UNITED STATES PATENT AND TRADEMARK OFFICE

Office Action Summary	Application No. 10/582,700	Applicant(s) EICHHOLZ ET AL.	
	Examiner Richard R. Green	Art Unit 4174

DETAILED ACTION

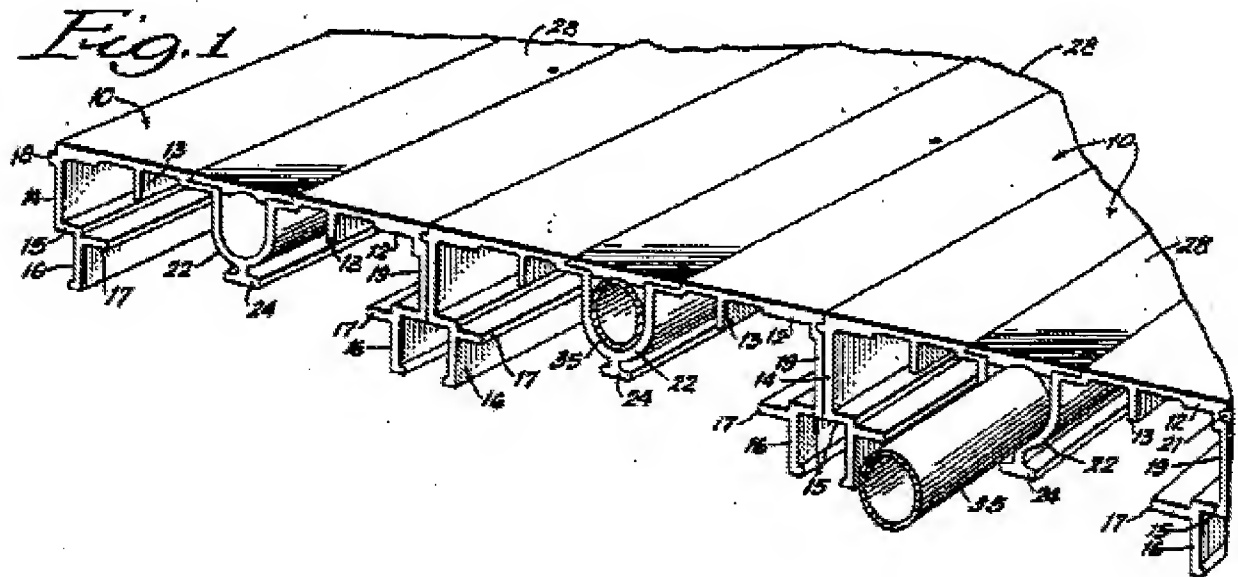
Claims 1-2, 4, 9, 14-15 are rejected under 35 U.S.C. 102(b) as being anticipated by US 2,799,481 (Becker).

Claim 1: Becker teaches floor heating, comprising:

a floor (fig. 1) made up of heatable panels (units 10, fig 1), characterized in that the panels have running through them first hollow chambers (22, fig. 1) and a feed line

(column 3 lines 22-24) connected to the first hollow chambers (16, fig. 2) for warm waste air which originates from the cooling of the aircraft's electronic equipment. While the panels disclosed are not taught for use in an aircraft or for "waste air which originates from the cooling of the aircraft's electronic equipment," they are disclosed for steam and are considered capable of being heated by waste air from an aircraft's electronic equipment.

Claim 2: Becker teaches floor heating in accordance with claim 1, characterized in that the first hollow chambers (22) extend in the longitudinal direction of the aircraft inside the panels (column 3, lines 5-6).

Claim 4: Becker teaches floor heating in accordance with claim 1, characterized in that the first hollow chambers (22) are in flow connection with second hollow chambers (22) in floor panels (10) of a cargo hold door (not shown) of the aircraft. The panels on the cargo hold door of applicant are disclosed to be similar to the panels on the floor and the panels of Becker are considered to be capable of use as panels for the cargo hold door as well. As for the chambers being in flow connection, applicant's sets of panels are connected by a member not shown, and so the panels of Becker can be considered in flow connection to the same degree as applicant's.

Claim 5: Becker teaches floor heating in accordance with claim 4, and the panels taught are considered capable of being arranged such that second hollow chambers abut the wall of the fuselage, which is considered to "terminate into the aircraft fuselage."

Claim 9: Becker teaches floor heating in accordance with claim 1, characterized in that the panels (10) are thermally uncoupled from a structure which supports the floor (column 4, lines 3-6). The depending shape of the panel heating conduits and the insulation taught are considered adequate to thermally uncouple the panel from the supporting structure.

Claim 14: Becker teaches floor heating in accordance with claim 1, characterized in that the panels (10) are provided with thermal insulation on their lower side (column 4, lines 3-6).

Claim 15: Becker teaches floor heating in accordance with claim 1, characterized in that the panels (10) are profile elements produced by extrusion, in particular by continuous extrusion (column 4, lines 8-9).

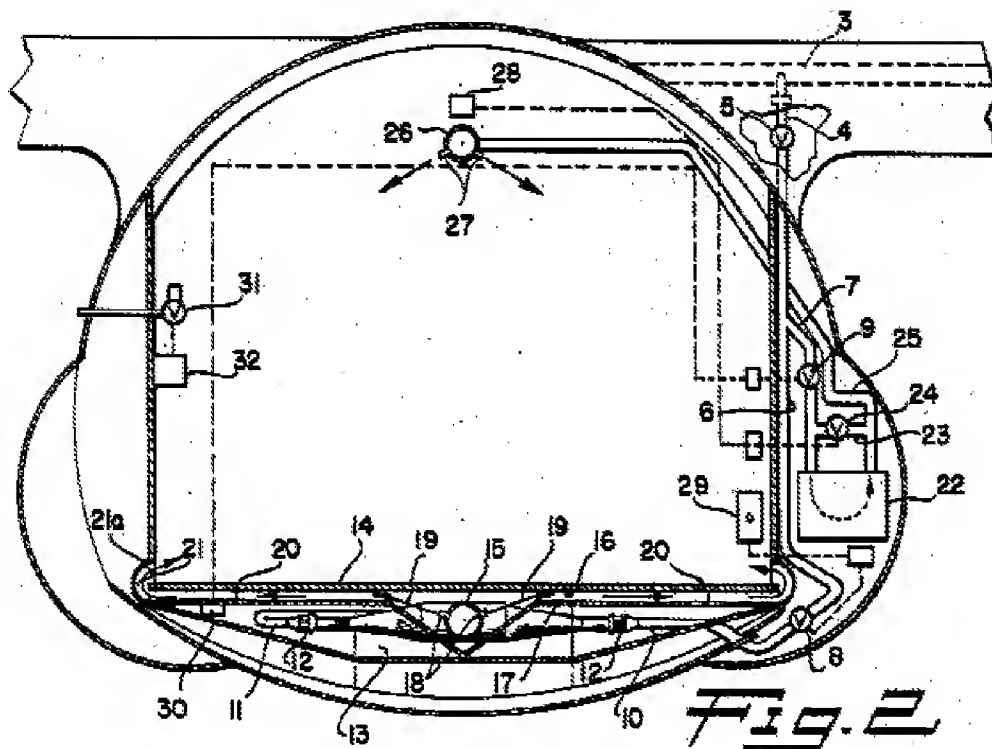
Claims 1, 2, and 13 are rejected under 35 U.S.C. 102(b) as being anticipated by US 3,203,473 (Goode).

Claim 1: Goode teaches floor heating for an aircraft, comprising a floor (14, fig. 2) made up of a heatable floor, characterized in that the floor has running through it first hollow chambers (16, fig. 2) and a feed line (6, fig. 2) connected to the first hollow chambers for warm waste air which originates from the cooling of the aircraft's electronic equipment. Though Goode does not disclose individual panels the entire floor can be considered as a panel, which is considered heatable. Goode does disclose hollow chambers (16, fig. 2) in the floor (14) through which hot air is fed by duct 6 (col. 2, lines 60-64), which can be considered a feed line.

Claim 2: Goode teaches floor heating in accordance with claim 1, characterized in that the first hollow chambers extend in the longitudinal direction of the aircraft inside the panels (better seen in fig. 1, but clear when seen that fig. 2 is a cross section that the spaces 16 extend longitudinally).

Claim 13: Goode teaches floor heating in accordance with claim 1, characterized in that ventilators (jet pump 12) are positioned in the hollow chambers in order to generate a forced flow through the hollow chambers. The jet pumps disclosed are considered capable of generating a forced flow through the hollow chambers, and are disclosed to be located in the hollow space of the floor.

FIG. 2

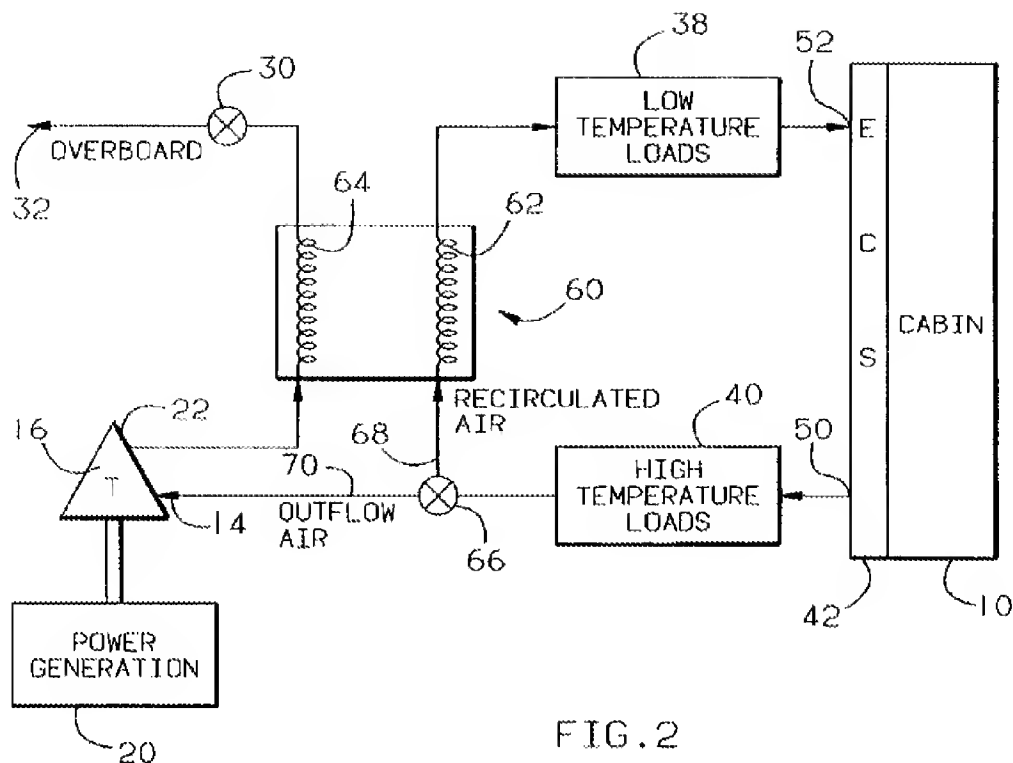
Claim 3: Becker teaches floor heating in accordance with claim 1, with first hollow chambers. Becker fails to teach a feed line connecting the hollow chambers with an avionics bay of an aircraft.

Severson teaches a low temperature load (38, fig. 2) which may comprise sensitive electronics such as avionics (col. 2, line 56), which, when cooled, dumps the waste air into the cabin of the aircraft through a port (52, fig. 2). Though Severson does not teach the use of the hot waste air to heat the floor of the aircraft, the floor panels disclosed by Becker require a heating medium and it would have been considered obvious to one of ordinary skill in the art to use the hot air from Severson in the panels of Becker for the purposes of heating the floor.

Claim 5: Becker teaches floor heating in accordance with claim 4, but does not teach chambers that specifically exhaust into a fuselage.

Severson teaches heating exhausts the air from second hollow chambers into electronics bays (item 40, fig. 2 Severson) which are considered to be a part of the fuselage. It would have been obvious to a person of ordinary skill in the art at the time of the invention to exhaust the air run through the panels of Becker into the fuselage of the plane as in Severson for the purposes of cooling high temperature electronics (col. 2, lines 50-53)

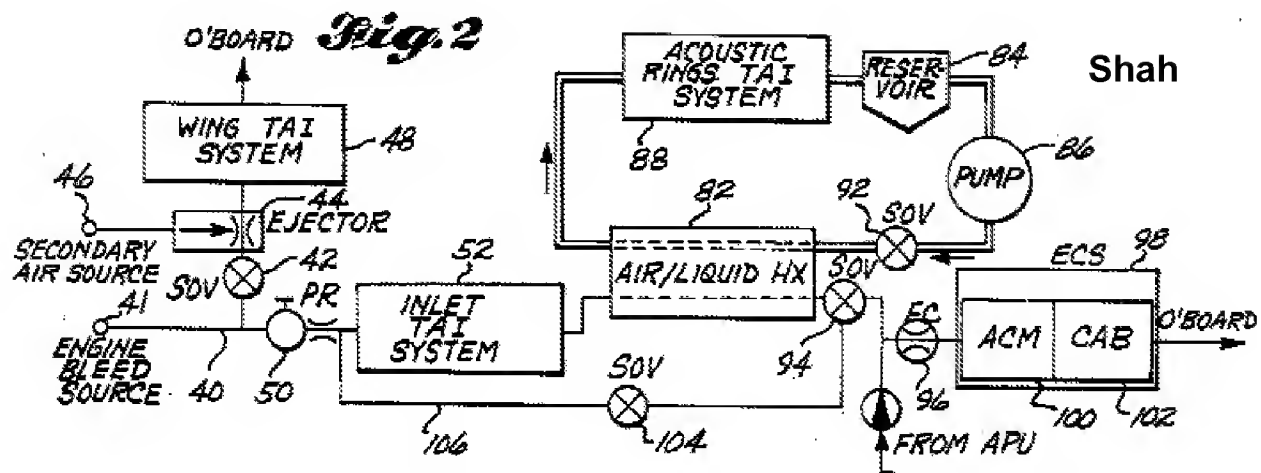
Claim 22 is rejected under 35 U.S.C. 103(a) as being unpatentable over Becker in view of Severson and Monfraix as applied to claims 16 and 19 above, and further in view of Goode and US 3,981,466 (Shah).

Becker teaches a method for heating a floor made of panels with hollow chambers arranged longitudinally (col. 3, line 6), but fails to specifically teach that warm waste air originating from the cooling of electronic equipment is conveyed through those hollow chambers, or that hot engine bleed air is mixed into waste air.

Severson teaches warm waste air originating from the cooling of an avionics bay (col.2, lines 53-56) in the aircraft conveyed to the cabin of the aircraft, wherein said cabin acts as a heat sink (col. 1, lines 25-30) and can be considered to be heated by the waste air. The waste air of Severson would have been obvious to run longitudinally through the panels of Becker for the purpose of heating a floor as previously stated regarding claim 16. Severson fails to teach a second mixing of hot engine bleed air with warm waste air from an avionics bay before the warm waste air flows through a cargo hold door.

Goode teaches a floor and ceiling heated by hot engine bleed air (col. 2, lines 5-10). It would have been obvious to a person of ordinary skill in the art to mix said bleed air with the warm waste air from the avionics bay for the purpose of heating the floor to a desired temperature not reached by one source of air alone as in Monfraix. Goode fails to teach mixing hot engine bleed air again prior to the cargo door.

Shah teaches an integrated deicer and environmental control system wherein hot engine bleed air is run through the deicer (52, fig. 2) before it is run to the environmental control system. Shah teaches an additional feed line (106, fig. 2) which runs directly to the environmental control system, which can be used when the aircraft cabin is not heated sufficiently by the bleed air that has already run through the deicing system (col. 5, lines 1-9). It would have been obvious to a person of ordinary skill in the art to use the secondary direct bleed air feed line of Shah (fig. 2, item 106) to direct hot engine bleed air directly to a second area to be heated in the case that the temperature of the hot bleed air / warm waste air blend that had passed through the floor already was insufficient to heat the second area to a desired temperature, similar to the reason given by Shah for the direct secondary feed.

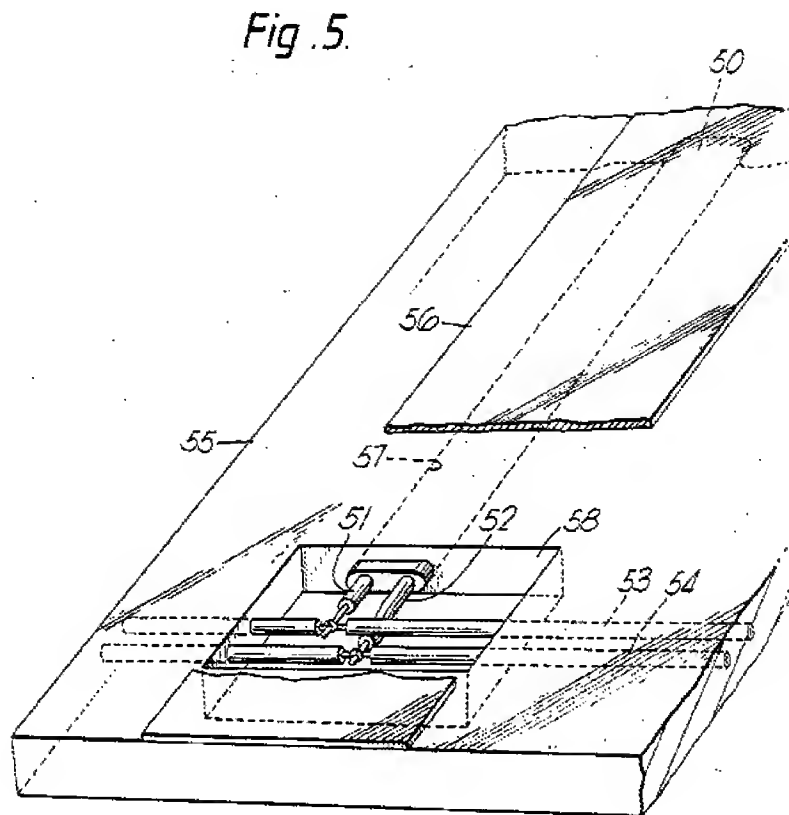
Claims 10-12 are rejected under 35 U.S.C. 103(a) as being unpatentable over Becker in view of US 4,733,057 (Stanzel) and US 6,611,659 (Meisiek).

Claim 10: Becker teaches floor heating in accordance with claim 1, but fails to teach that panels are provided with electric heating mats for supplementary heating.

Stanzel teaches an electric heater for installation under a floor for the heating of said floor, but fails to provide a reason for installation in addition to another source of heat.

Meisiek teaches an electric heating mat for installation in the floor of an aircraft for purposes of heating a floor in combination with another cabin heating system "in order to achieve homogenous surface temperatures at the floor level," (paragraph 11). It would have been obvious to a person of ordinary skill in the art to install the electric heater of Stanzel in the floor panel of Becker, perhaps in the additionally provided chambers visible at arrows 17 in figure 1 of Becker, for the purpose of heating areas of

the floor not sufficiently heated by the warm waste air of Severson, for the same reason as Meisiek; to "achieve homogenous surface temperatures at the floor level."
